CINTICHEM, INC.

December 15, 1992

Reference: (a) USNRC Letter, D. Orlando (Docket 50-54, 70-687)  
dated December 4, 1992

The referenced letter requested additional information in support of the Cintichem, Inc. proposed residual soil contamination acceptance criteria that were included in our initial submission dated July 15, 1992 and recently modified in our submission dated October 22, 1992.

CINTI41.DAT

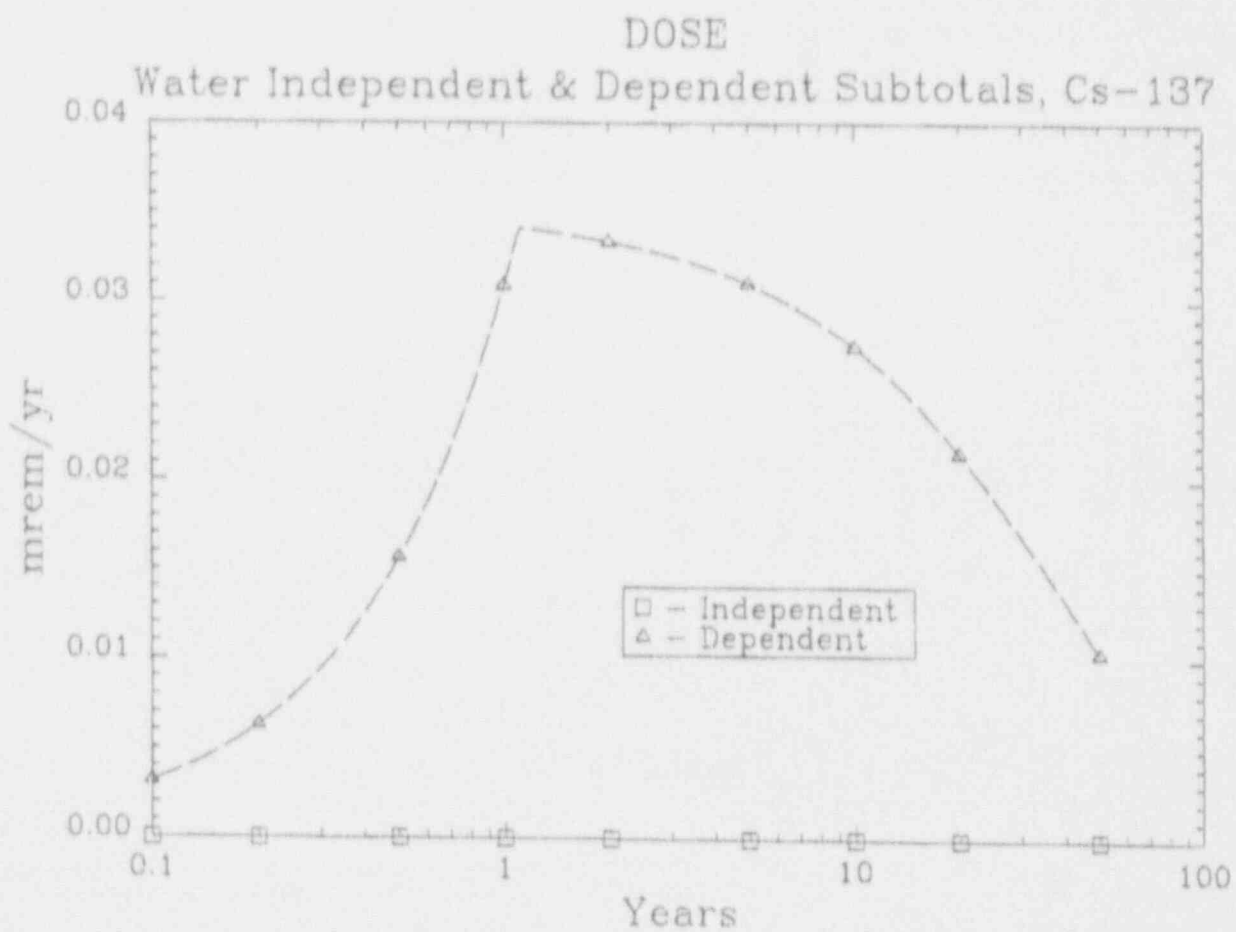
The following graphs present RESRAD calculations for the most significant radionuclides that have been found in the subsurface contaminated zone. As may be noted, all of these isotopes will reach their peak dose rate contributions at different times. The most significant contributors to dose are Sr90 and Cs137 and they peak at approximately 3 months and 1 year respectively after disposition in the soils. The other radionuclides of Ag110m, Co60, Ce144 and Eu152 also peak at different times but they are all at least an order of magnitude less than Sr90 and Cs137 at their respective peaks.
